CONCEPTION-NEW JERSEY SUBDIVISION

APPLICATION NUMBER 4 DATE January 3, 2008

REQUEST Subdivision

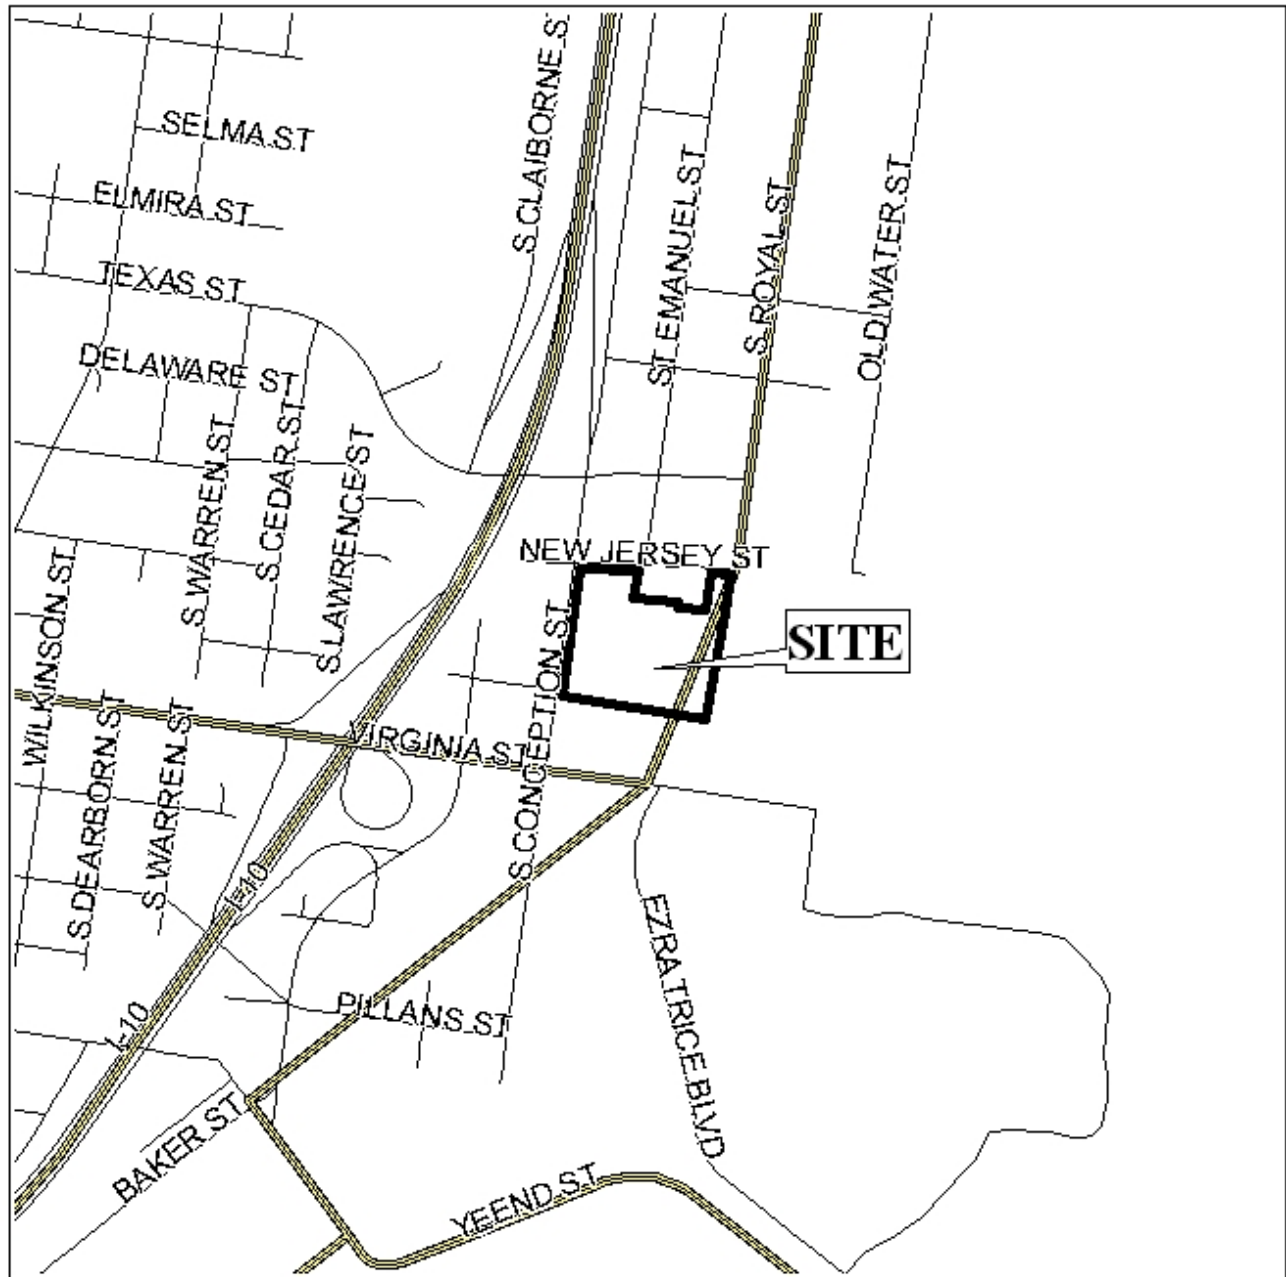
The site fronts Conception Street, with a 64' right-of-way, and New Jersey Street, with a 50' right-of-way, both minor streets and compliant with Section V.B.14. of the Subdivision Regulations. No radius is indicated at the Southeast corner of Conception Street and New Jersey

Street; therefore the plat should be revised to indicate the dedication of a 25' radius curve at this intersection. Otherwise, no right-of-way dedication is required.

The site has approximately 575' of frontage along Conception Street, and approximately 295' of frontage along New Jersey Street; therefore, a note should be placed on the final plat stating that the site is limited to two curb cuts to Conception Street, and one curb cut to New Jersey Street, with the size, location and design of all curb cuts to be approved by Traffic Engineering and conform to AASHTO standards.

No building setback line is indicated on the plat; therefore the plat should be revised to illustrate the 25' minimum building setback line along both street frontages. As no lot size in acreage is indicated on the plat, it should be revised to label the lot with its size in acreage, or a table should be provided furnishing the same information.

One point that was erroneously omitted from the original staff report is that the site appears to lie in the path of the Royal Street South major street corridor. This section of the major street does not follow existing right-of-way, and therefore the exact path of the corridor is not

determined. While the City of Mobile Major Street Plan illustrates Royal Street as a major street, it is not reflected on the MATS 2030 plan; and, therefore, is unlikely to be constructed. Further, the plan indicates an 80' right of way for the Royal Street South major street, which would require not only acquisition of additional rights of ways, but in numerous cases would also require acquisition of structures.

Another point that should be addressed is a FEMA requirement of which the staff has only recently become aware. It is our understanding that FEMA requires a flood study for all developments (applications) located within the AE flood zone that contain 50 or more lots – or a total of 5 acres. As the site in question contains 8.3± acres, a flood study may be necessary prior to recording of the final plat.

- 1. dedication of a 25' radius curve at the intersection of Conception Street and New Jersey Street;*
- 2. placement of a note on the final plat stating that the site is limited to two curb cuts to Conception Street, and one curb cut to New Jersey Street, with the size, location and design of all curb cuts to be approved by Traffic Engineering and conform to AASHTO standards;*

- 3. the plat be revised to illustrate the 25' minimum building setback line along both street frontages;*
- 4. the plat be revised to label the lot with its size in acreage, or a table should be provided furnishing the same information;*

- 5. placement of a note on the final plat stating that the site may be impacted by the path of the Royal Street South major street, and that any development on the Eastern portion of the site may require setbacks from the future right-of-way of the planned major street; and*

- 6. provision of a flood study, if deemed appropriate to comply with FEMA regulations, prior to signing and recording of the final plat.*
